STAFF REPORT

TO: Planning Commission
FROM: Emily Becker, City Planner
AGENDA ITEM: Lakewood Crossing 2nd Addition General Planned Unit Development
Concept Plan
REVIEWED BY: Stephen Wensman, Planning Director

MEMORANDUM

Re: Lakewood Crossing 2nd Addition
Concept Plan Review

A2.1

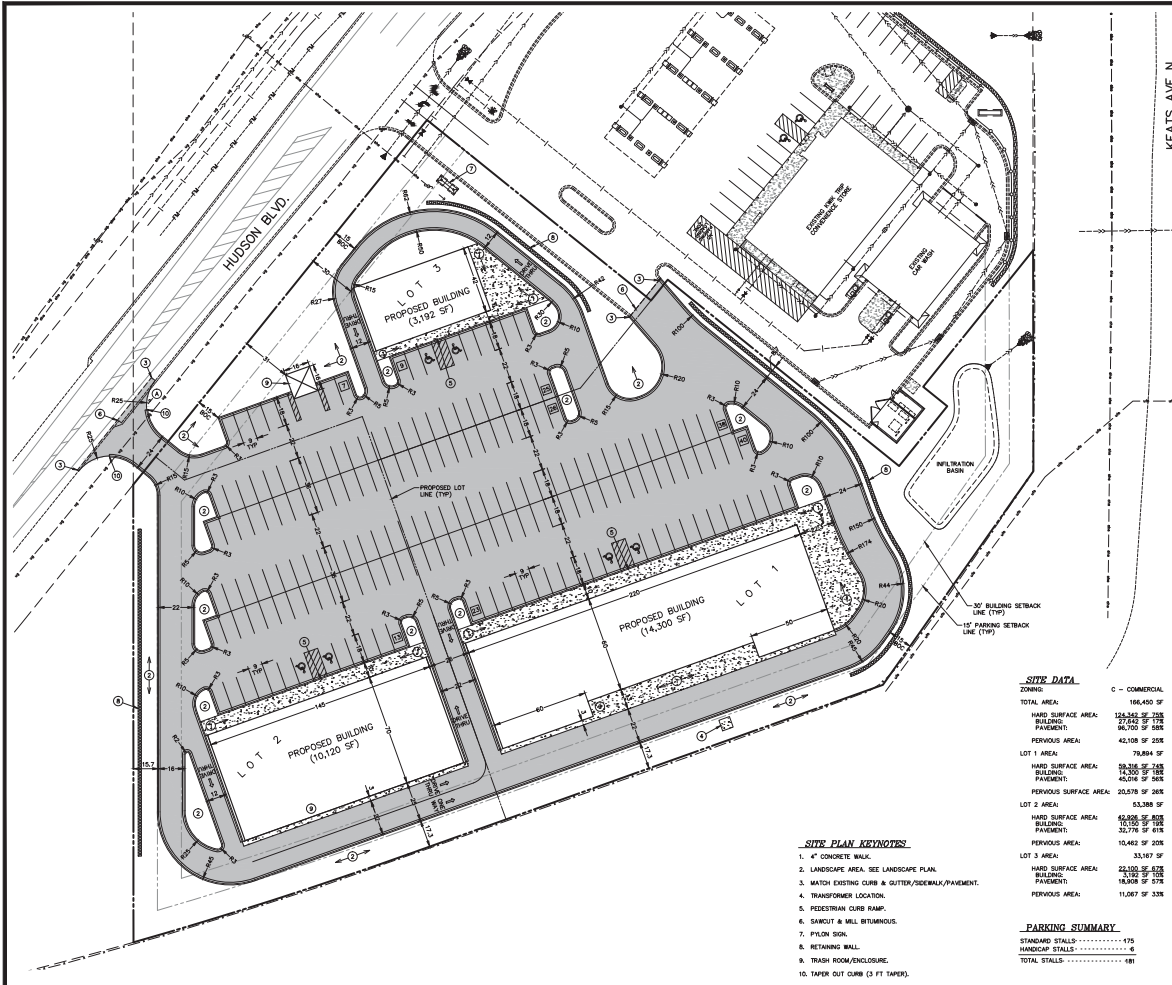
<i>Building Form and Façade</i>	Blank façades discouraged. Significant amount of transparent glass. Minimize continuous expanses of walls.	The proposal includes canvas awnings, cornices, and a significant amount of windows.
<i>Building Materials</i>	High quality, durable materials. Brick, finished wood, stone, cast stone, pre-cast concrete panels. High quality synthetic materials, if approved by the City, are allowed. Colors of subtle earth tones.	The building materials consist of standing seam metal roof, metal canopy, cultured stone, face brick, and canvas awning. Colors not indicated.
<i>Scale and Mass</i>	Builds broken down into smaller parts to avoid monotony and continuity. Multiple roof and ridgelines.	Proposal employs varying roof heights and is broken down in to different building materials.
<i>Roof Design</i>	Roof design consistent with overall architecture or design. Parapets of varying heights required. Rooftop equipment screened.	Varying parapet roofs. It is a recommended condition of approval that rooftop equipment be screened.

<i>Entries</i>	Accessible for pedestrians. Architectural features incorporated. Canopies, awnings, other sheltering encouraged.	Accessible from the parking lot. Canopies proposed.

18. Mechanical rooftop equipment must be screened.
